STATION HILL READING

AMENDMENTS TO PLANNING PERMISSION REF:
192032/PHASE 2 STATION HILL

JUNE 2023

Changes to the Pocket Park and Planters to the Upper Ground

The key changes

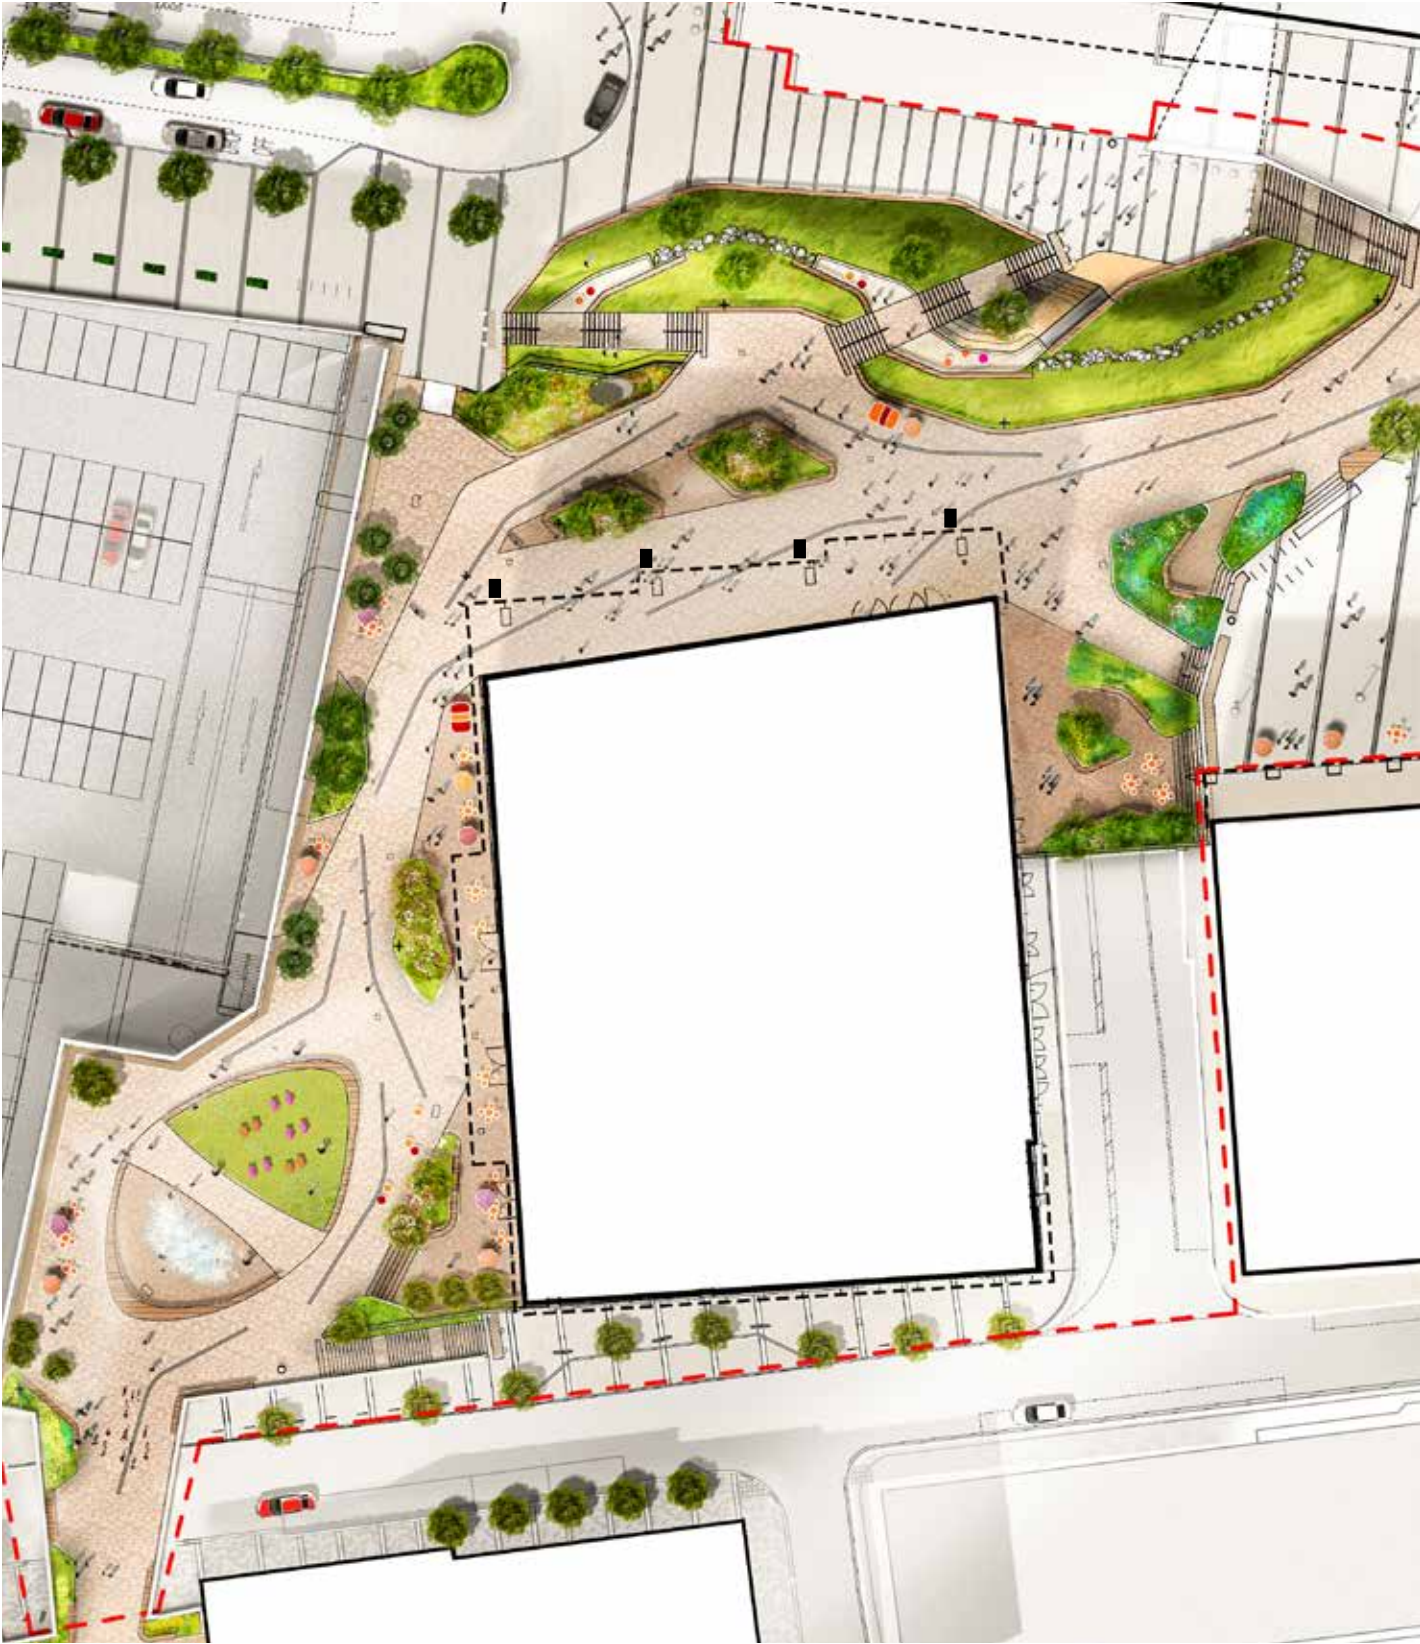
- The footprint of the Pocket Park is adjusted so that the alignment of the existing taxi rank does not need to be modified. This necessitates a slight alteration to the north-western boundary of the retaining wall/bench and planting at the lower level. The overall area increases from 1,066m² to 1,158m².

- The eastern set of steps leading from the lower the upper levels are realigned to work more closely with desire line from the tunnel to the upper level.

- The western set of steps leading from the taxi rank/bus stop follow the line of the wall to the upper ground and deliver users more directly to Station Square.

- Planters at upper levels are rationalised to create clearer pathways that align with desire lines. There is no loss of green or soft planting areas. Additional trees are provided.

- There is no loss of seating area.
- Planters at upper ground have been combined to create more soil volume for trees, to create clearer pathways and a more clearly defined central gathering space. The number of trees has increased by one to 44 across the site.

- The slide from upper to lower levels previously proposed is removed in response to safety and public order concerns.

LANDSCAPE: COMPARISON OF CONSENTED AND PROPOSED

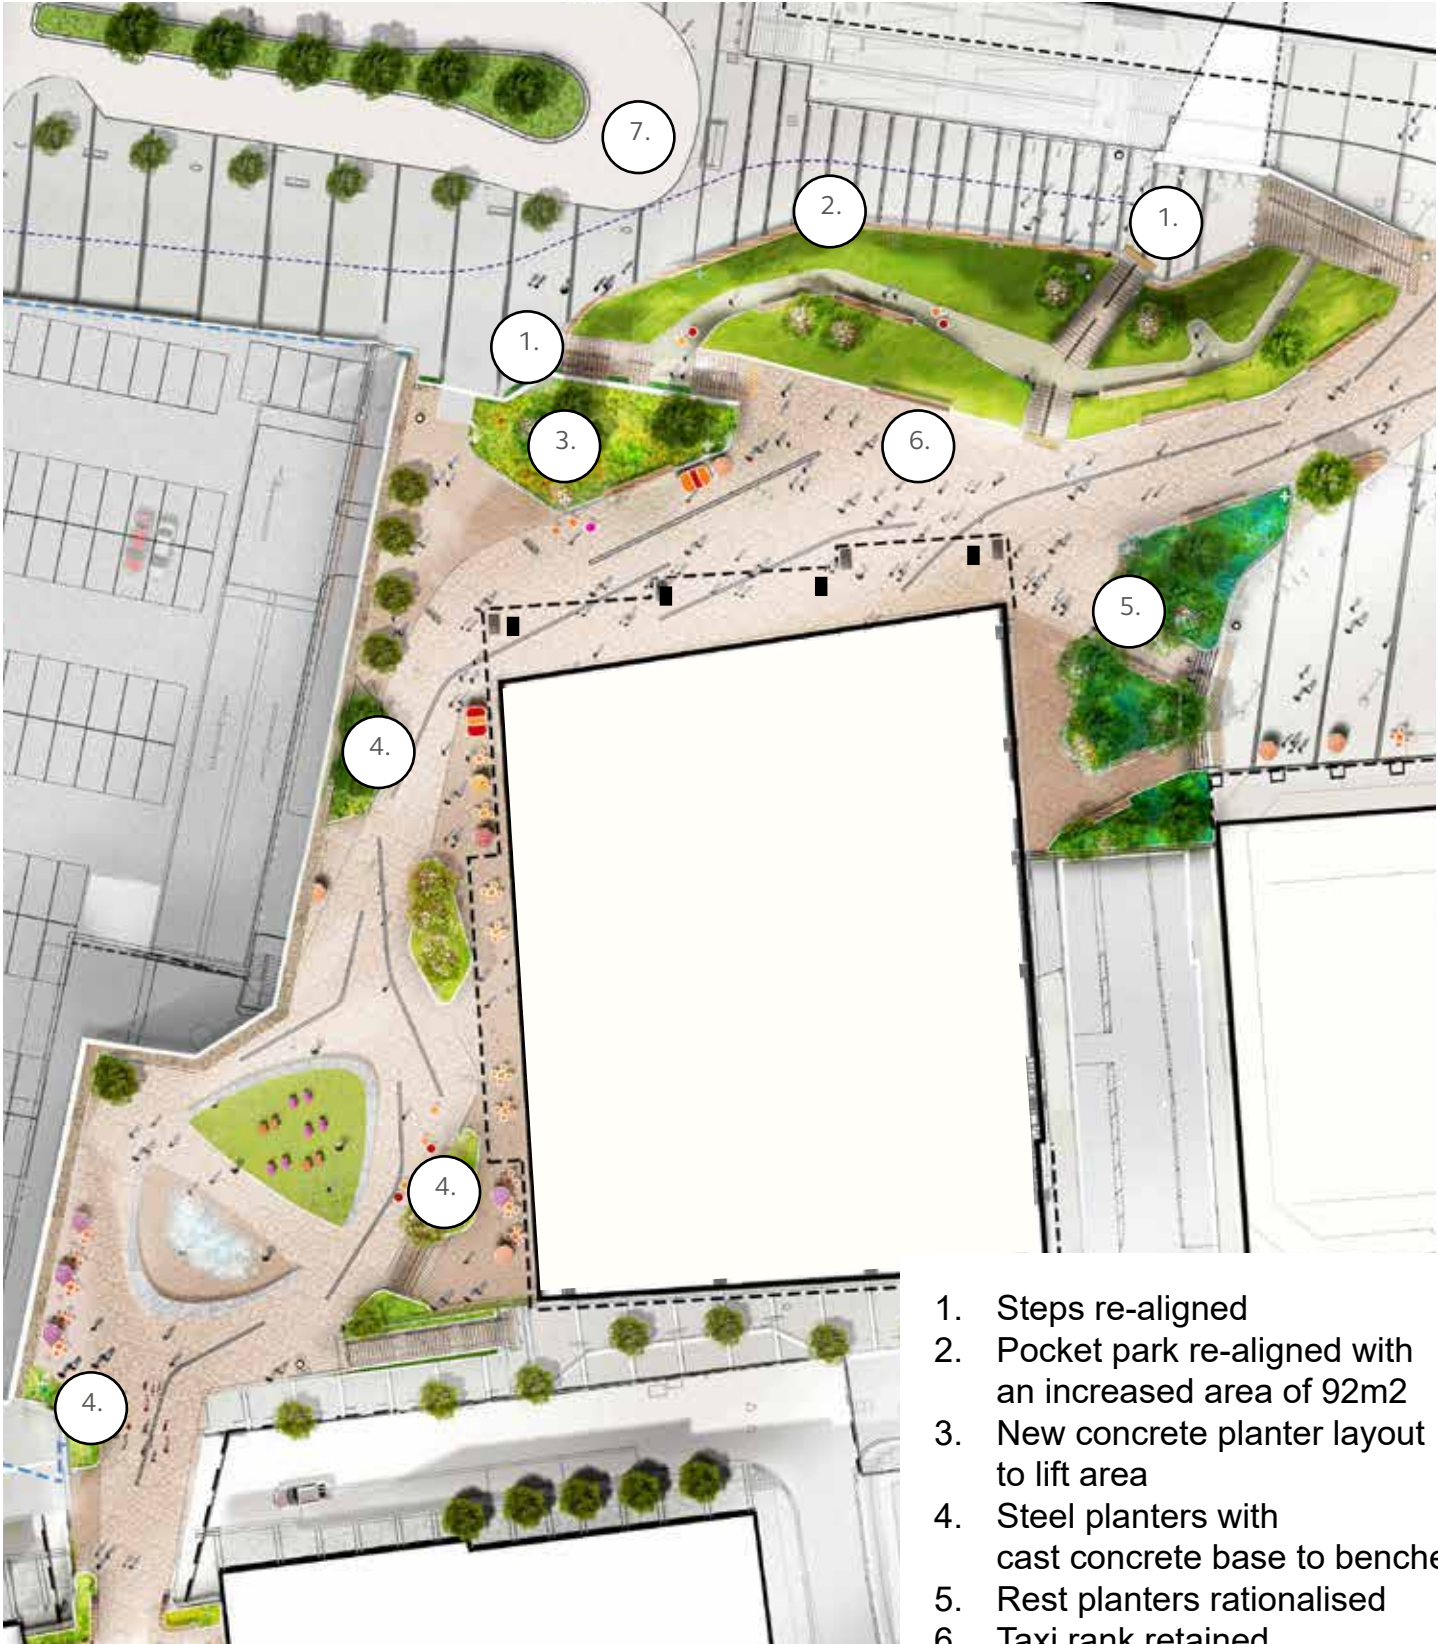
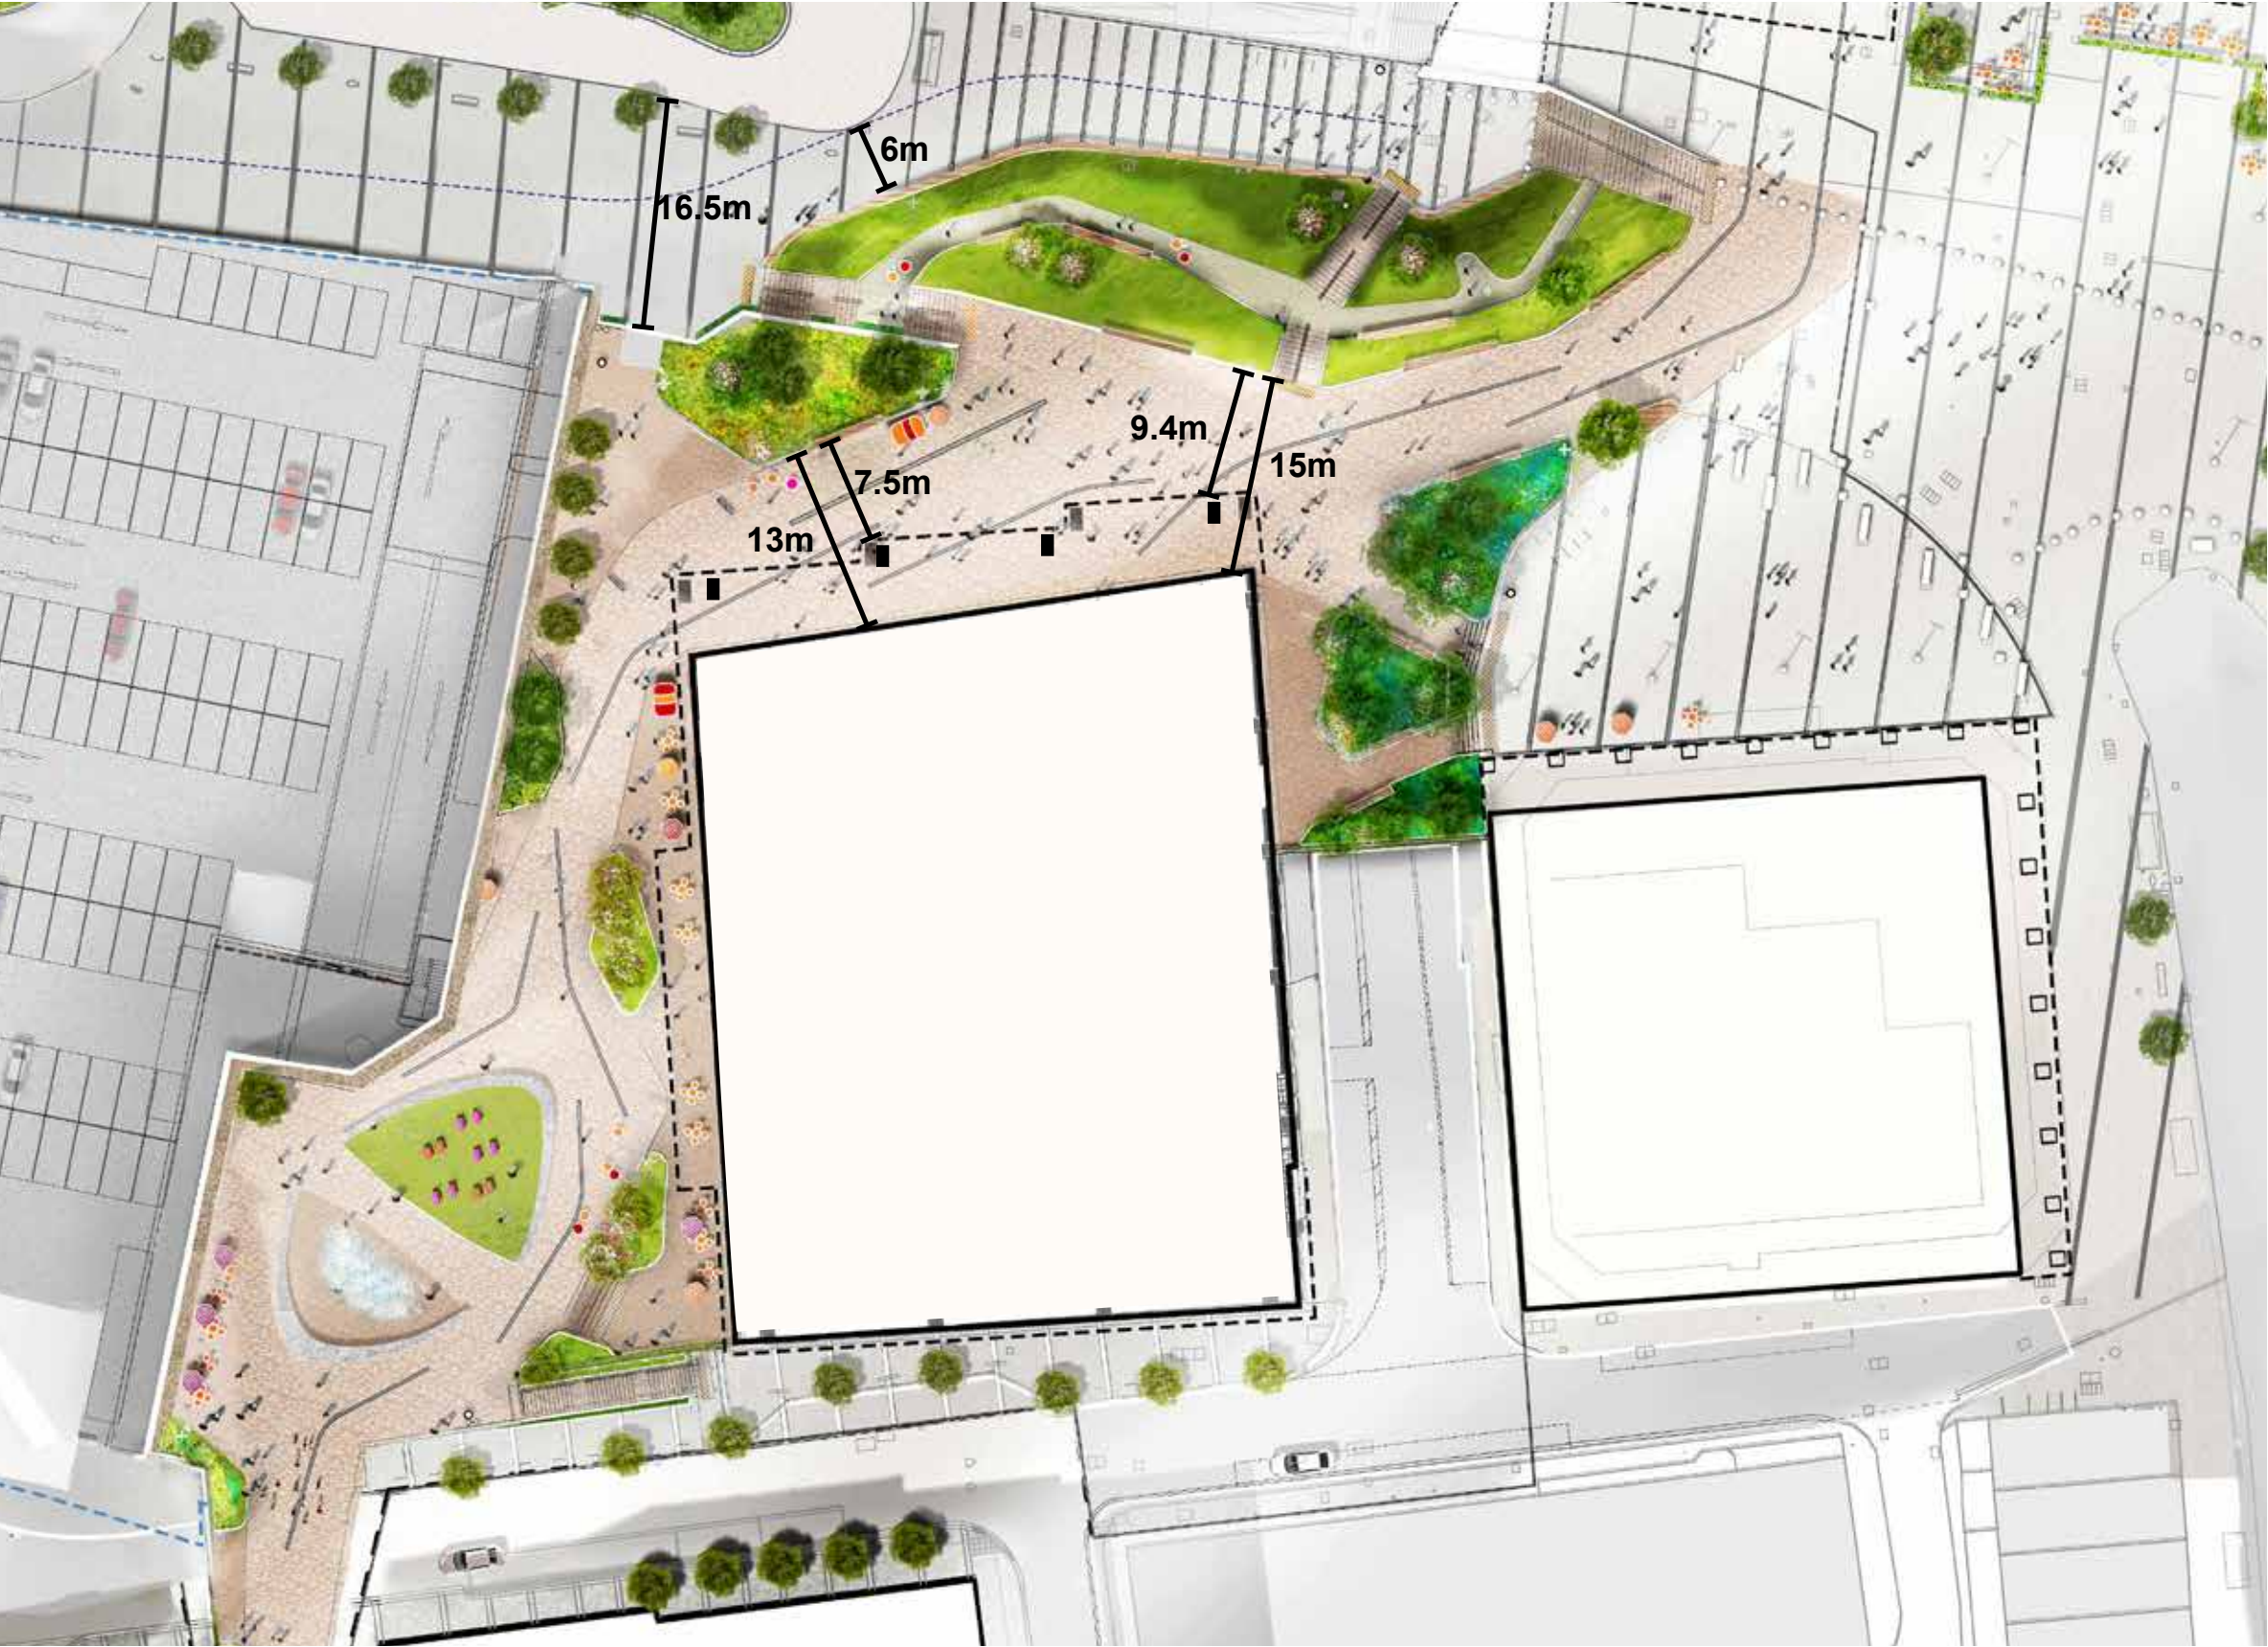
- 1. Steps re-aligned
- 2. Pocket park re-aligned with an increased area of 92m2
- 3. New concrete planter layout to lift area
- 4. Steel planters with cast concrete base to benches
- 5. Rest planters rationalised
- 6. Taxi rank retained
